# Draft RD/RAWP VES-SFE-20 Hot Waste Tank System Comments – Resolutions to Draft Final Document Review, Comment, Resolution List – EPA

| DOCUMENT TITLE: Remedial Design/Remedial Action Work Plan for the VES-SFE-20 Hot Waste Tank System (Draft Final) | | | | |

# Draft RD/RAWP for the VES-SFE-20 Hot Waste Tank System Comments — Resolutions to Draft Final Document Review, Comment, Resolution List – IDEQ

ENLARGED VIEW

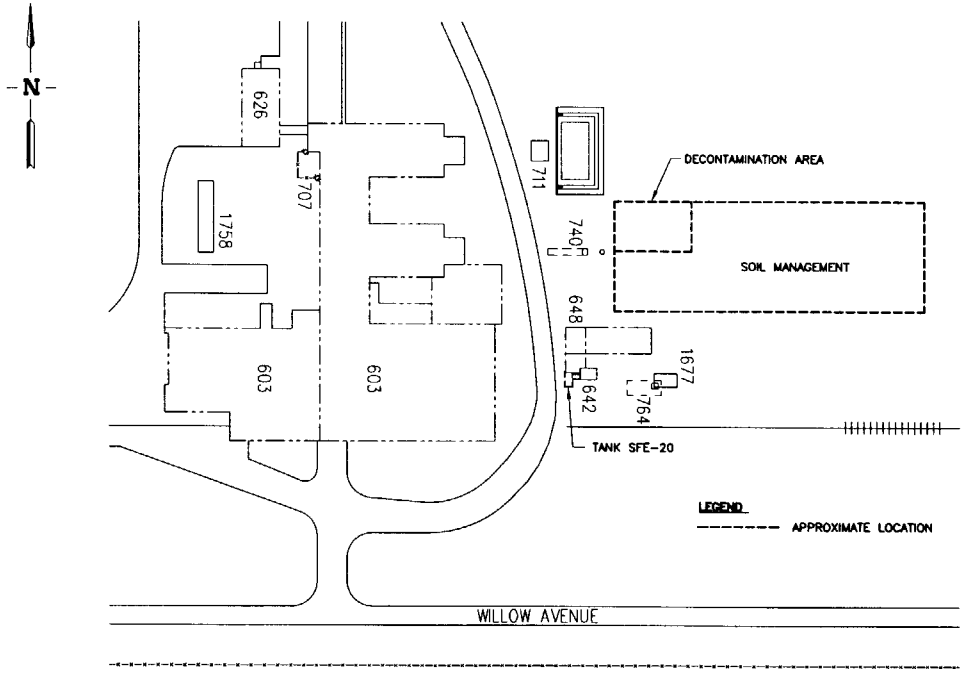
| DOCUMENT TITLE: Remedial Design/Remedial Action Work Plan for the VES-SFE-20 Hot Waste Tank System (Draft Final) | | | | |
|---|---|---|---|---|
| 5. | DOE/ID 11049, Section 5.3 Storage and Inspection, First paragraph, Third sentence | 14 | Clarify what is meant by staging of the waste (piles or containers) "in proximity" to the remediation site. Discussions during the draft comment resolution indicated that the staging area would be marked on a drawing. The area depicted on drawing T-1 identifies only a general area for soil management; subcontractor lay down, decontamination, and monitoring/sampling. The location where each of these activities will be performed must be clearly identified in the final RD/RA Work Plan (Waste Management Plan). | Document revision.<br>(a) Section 5.3 (WMP), 1st paragraph, 3rd sentence shall be revised as follows: "If waste is staged prior to treatment and disposal, the waste will be staged in the designated area depicted in the RD/RA Work Plan Figure 6-1."<br>(b) Figure 6-1 (RD/RA Work Plan) will be revised, see figure below. |
